**Town of Kittery
 Planning Board Meeting
 April 12, 2018**

Estes Business Park – Sketch Plan Review

**Re: Sketch Plan Application
Estes Business Park
U.S. Route 1**

OVERALL SITE PLAN
ESTES BUSINESS PARK
U.S. ROUTE 1
KITTERY, MAINE

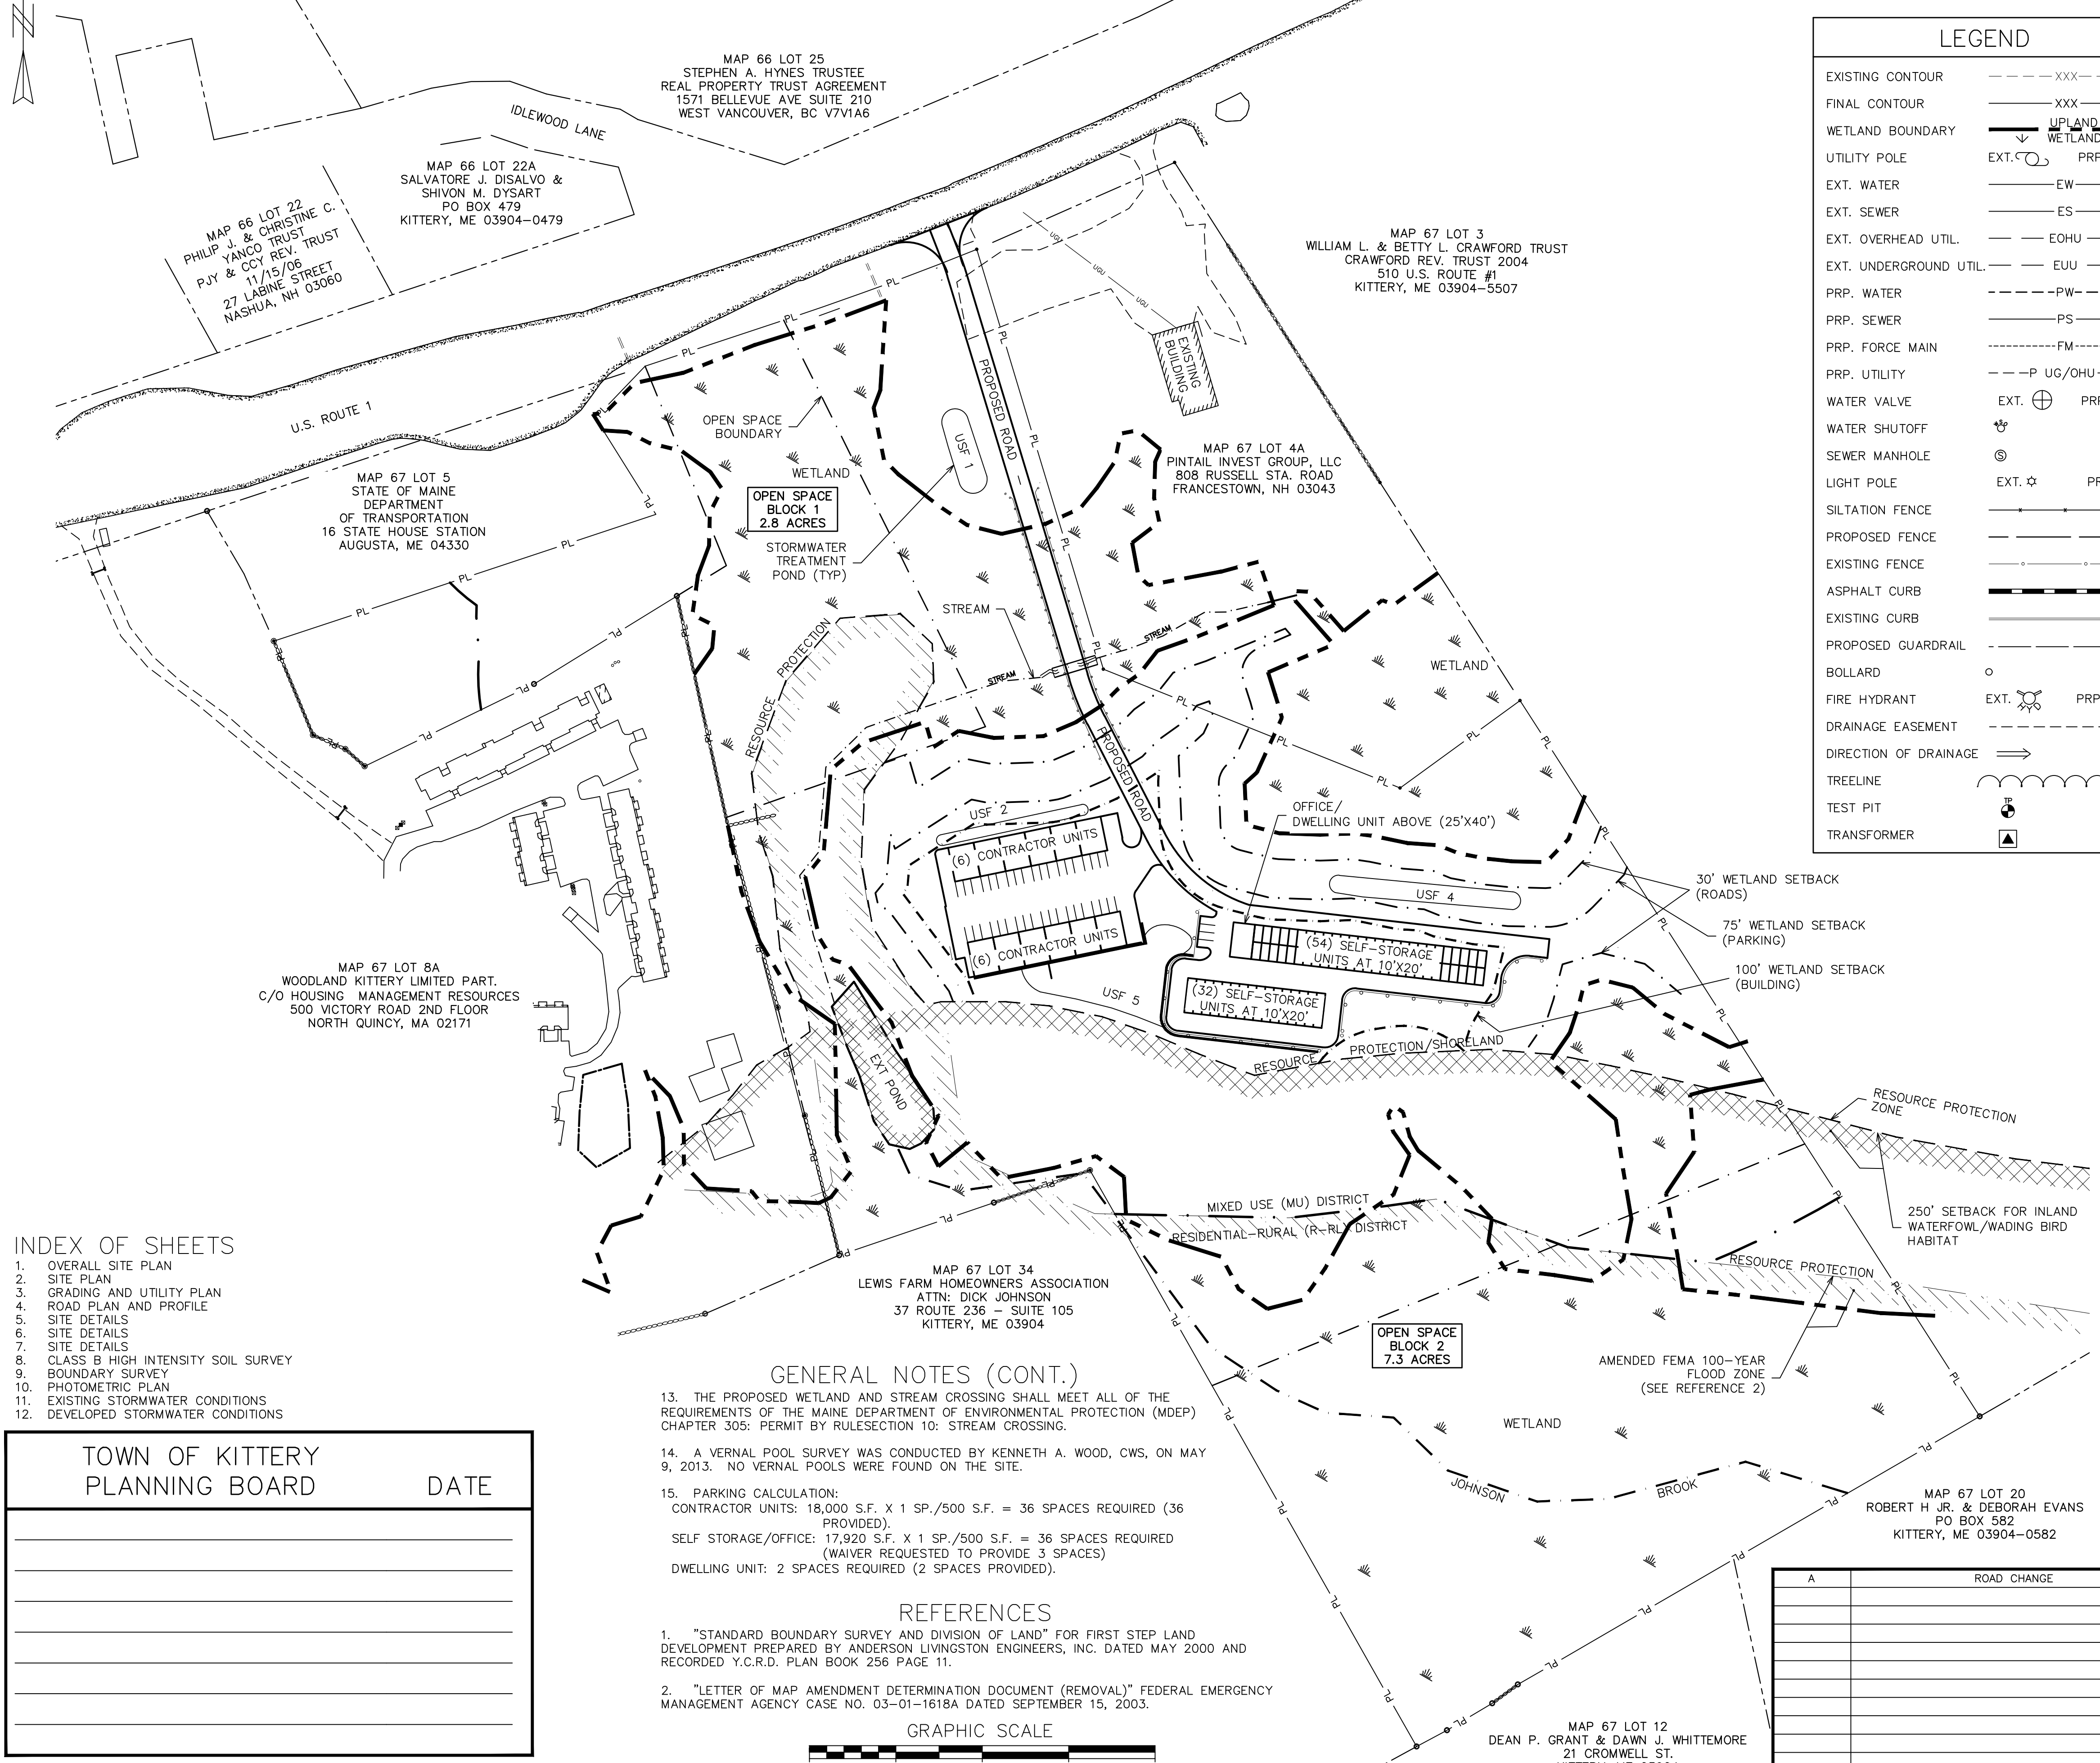
12. A minimum of 35% of the total lot must be designated as open space. Two open space areas are shown and labeled on the plan. Note 6 states that the two areas add up to the required 35%. The open space area in the front labeled Block 1 is 2.8 acres and Note 6 states that it meets the requirement that 25% of the open space be located in the front 50% of the lot area closest to Route 1.

*OPEN SPACE BLOCK 1 (27.8%) IS LOCATED IN THE FRONT 50% OF THE LOT, MEETING THE REQUIREMENT THAT 25% OF THE REQUIRED OPEN SPACE BE IN THE FRONT 50% OF THE LOT AREA CLOSEST TO ROUTE 1.

SCALE:	APPROVED BY:	DRAWN BY:
1" = 100'		BN
DATE:		REVISION : DATE
12/20/2017		A : 3/22/2018
JOB NO: COB2-18	CAD FILE: ESTES.BASE.DWG	SHEET 1

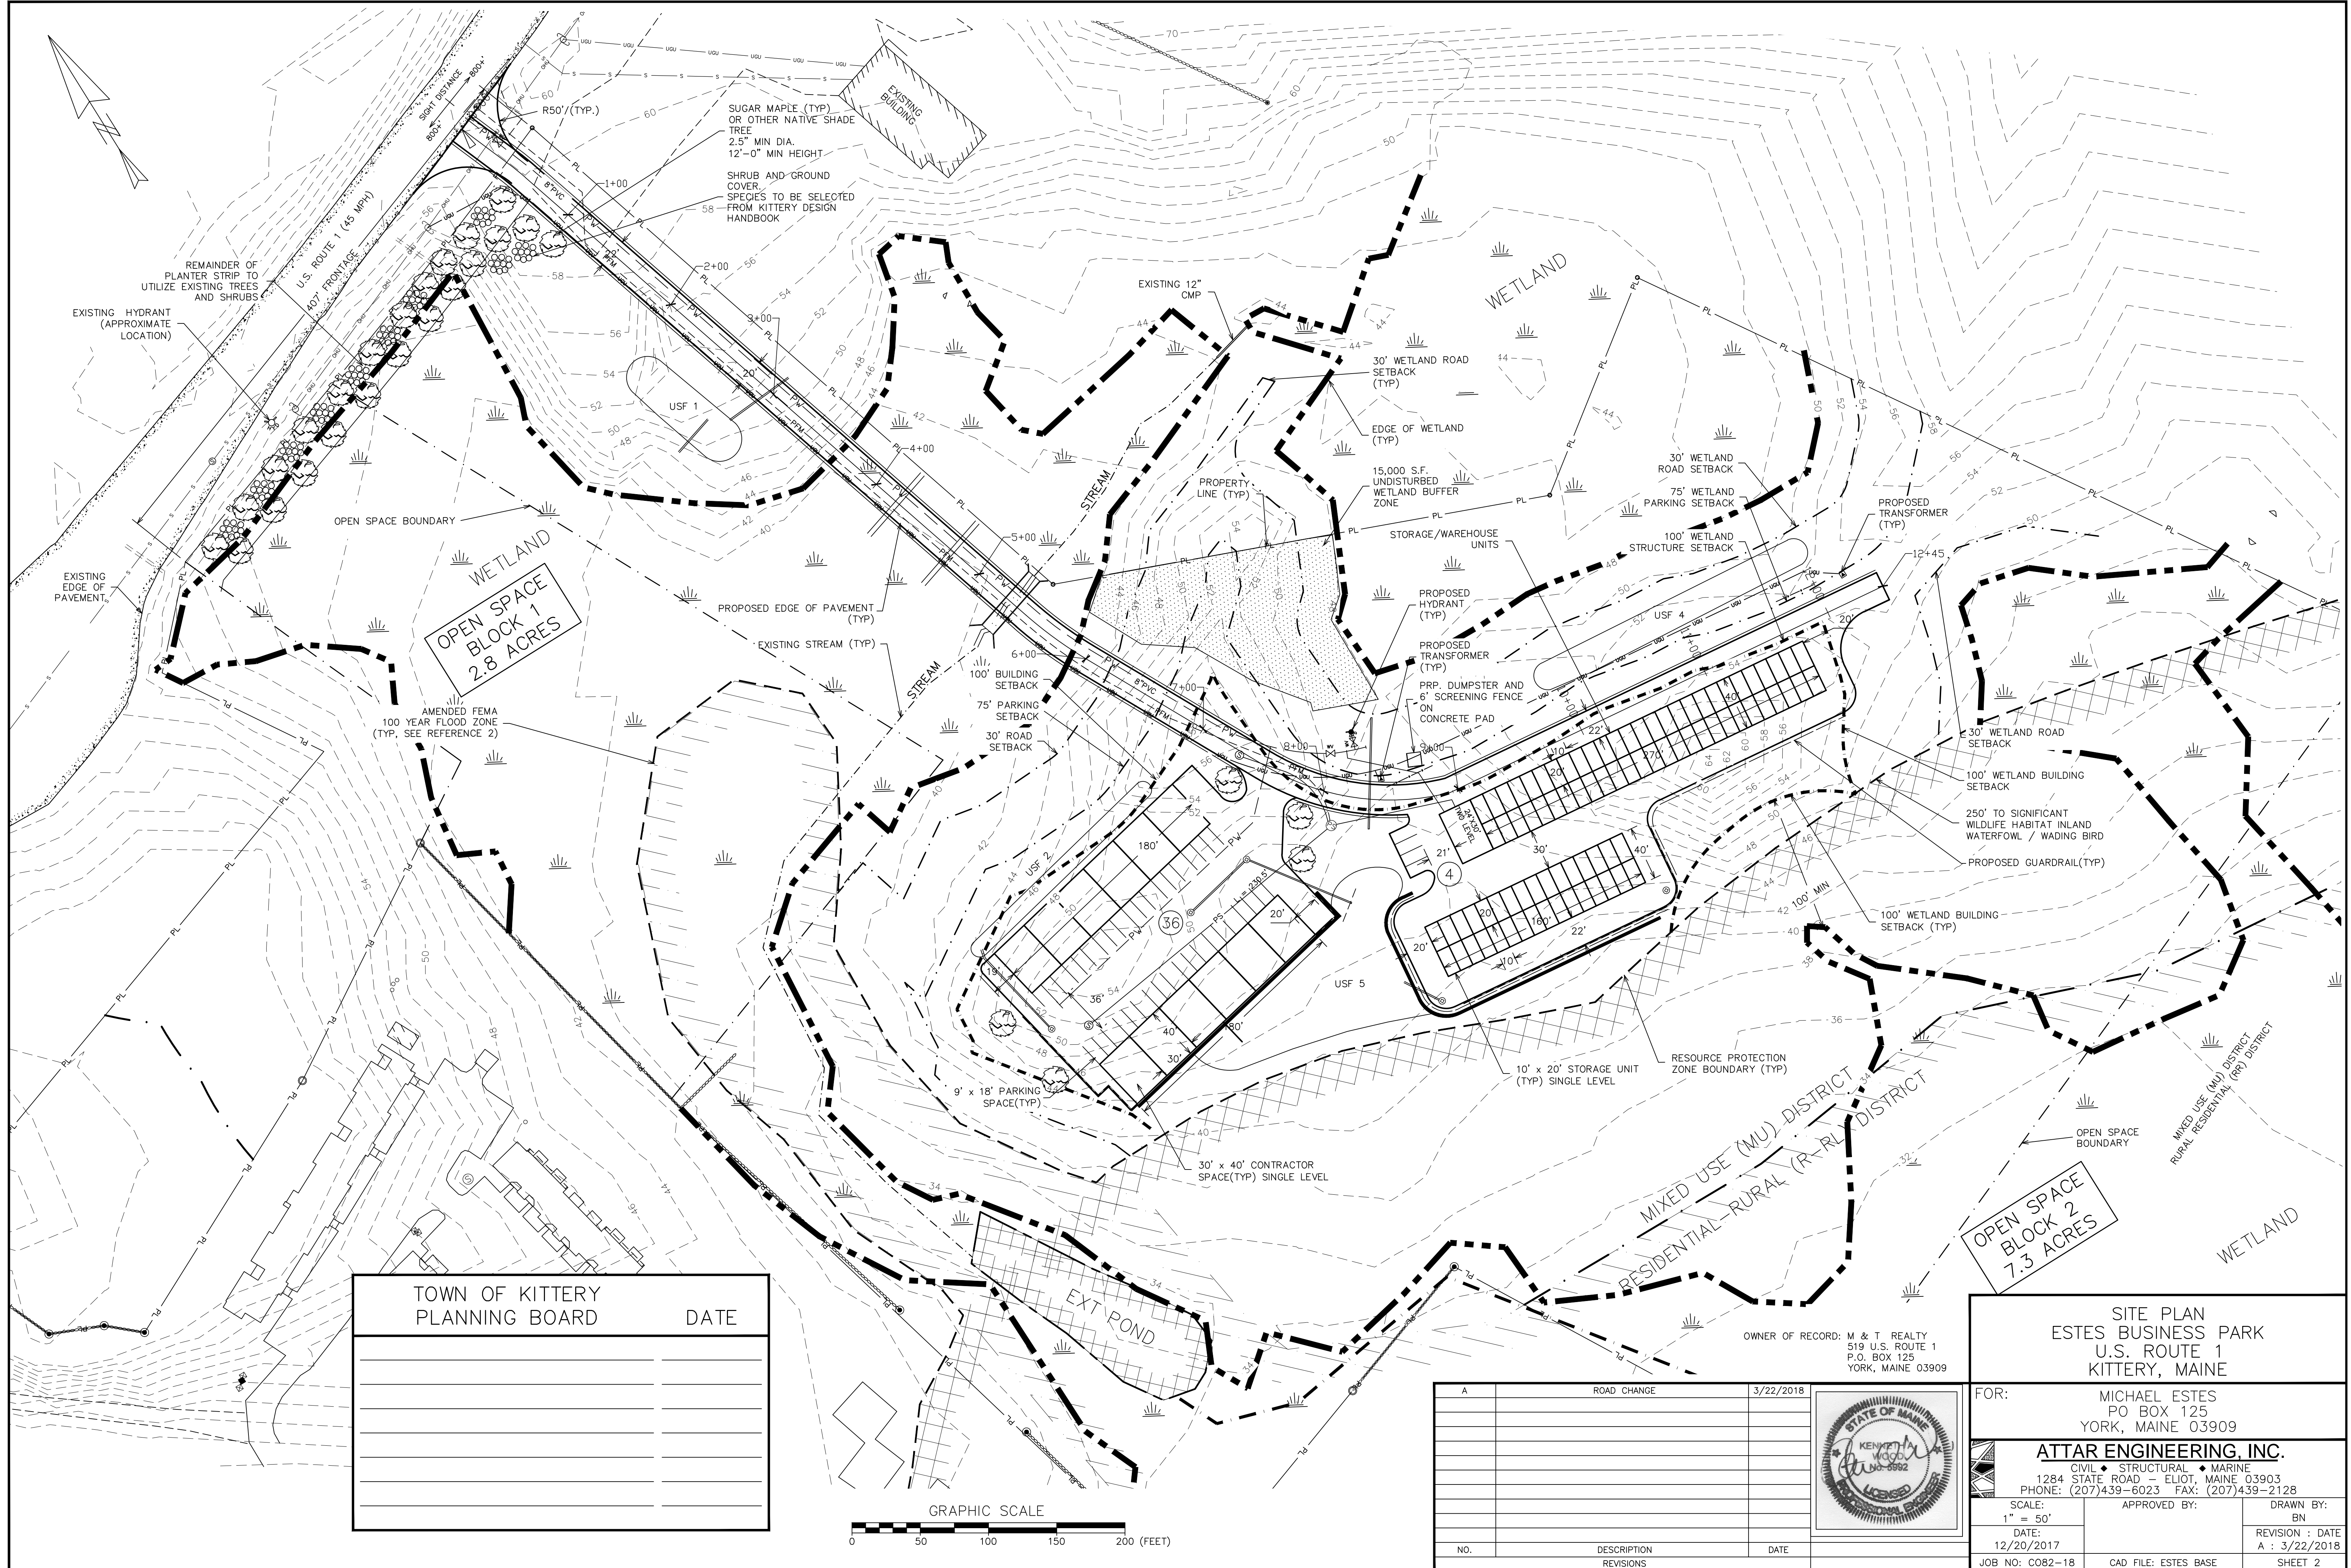
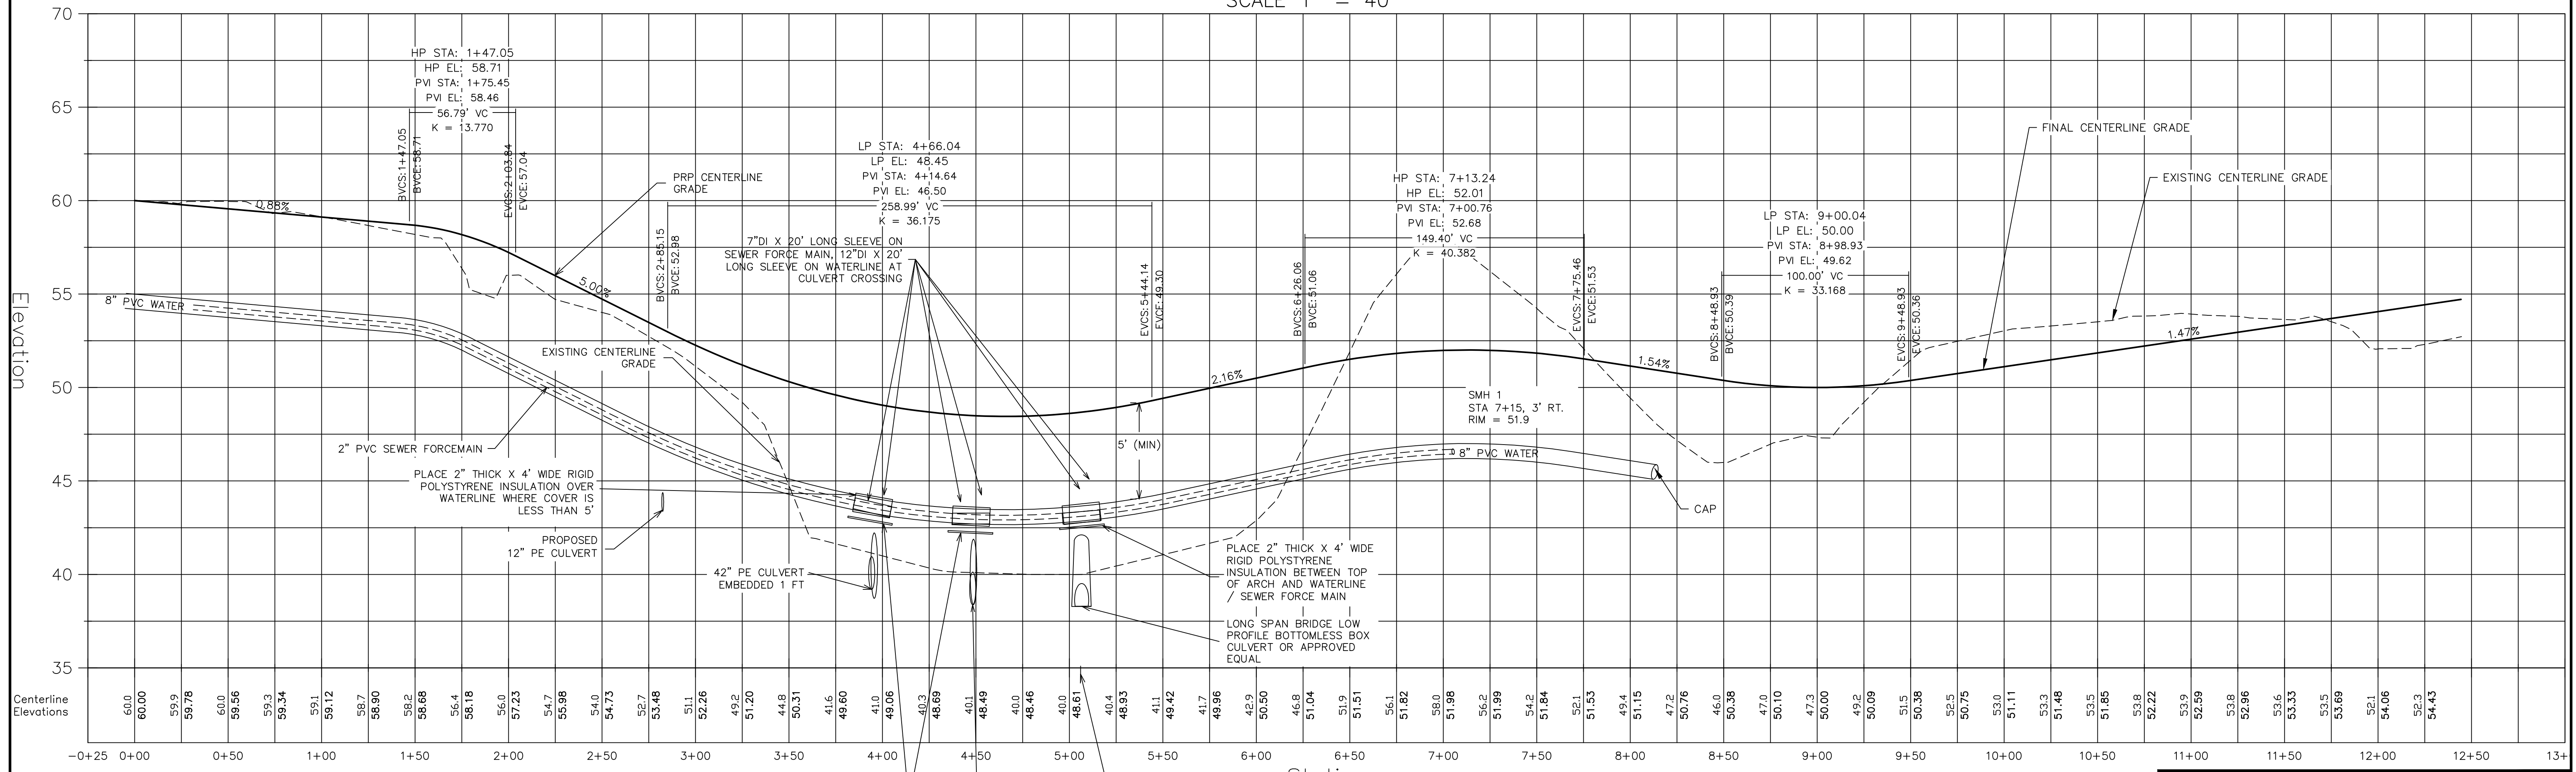
- All development proposed is outside the Resource Protection Zone.
- The buildings as proposed are outside the 100-foot building wetland setbacks
- Stormwater ponds #2 and #4 are between the 100-foot and 75-foot setback for wetlands not associated with the Resource Protection Zone. Stormwater pond #5 is outside the Resource Protection Zone
- Stormwater pond #1 along the road does not show the wetland setback (and should) but appears to be a bit over 25 feet from the wetland edge.

- Retaining walls that staff could identify are outside the 100-foot wetland setback with one possible exception in the southeastern corner of the self-storage building. Guardrails shown are outside the 100-foot setback although it isn't clear how far along the southern perimeter they run. Where are the retaining walls and guard rails proposed to be located?

- Roads, the dumpster and the dumpster's concrete pad are outside the 30-foot road wetland setback allowed. A road around the perimeter of the shops in pursuit of trade buildings has been removed because it could not meet the wetland setbacks.

5. No snow storage locations are currently shown on the plan that staff could find, although the submission letter indicated they were. Where will they be located?

11. The plans depict a planting strip with trees along Route 1 and five more trees scattered around the shops in pursuit of trade buildings which a note says will be sugar maples. Another note says that the remainder of the planting strip will utilize existing trees and shrubs. It isn't clear what the placement and dimensions of the planting strip are – it must be 30 feet wide with a tree every 25 feet per standards outlined in 16.3.2.13.D.6. Are the trees shown in the wetland existing? More details are needed.

Snow Storage areas have been identified on the plan.

Additional landscaping has been specified for the landscaped planter strip adjacent to Route 1.
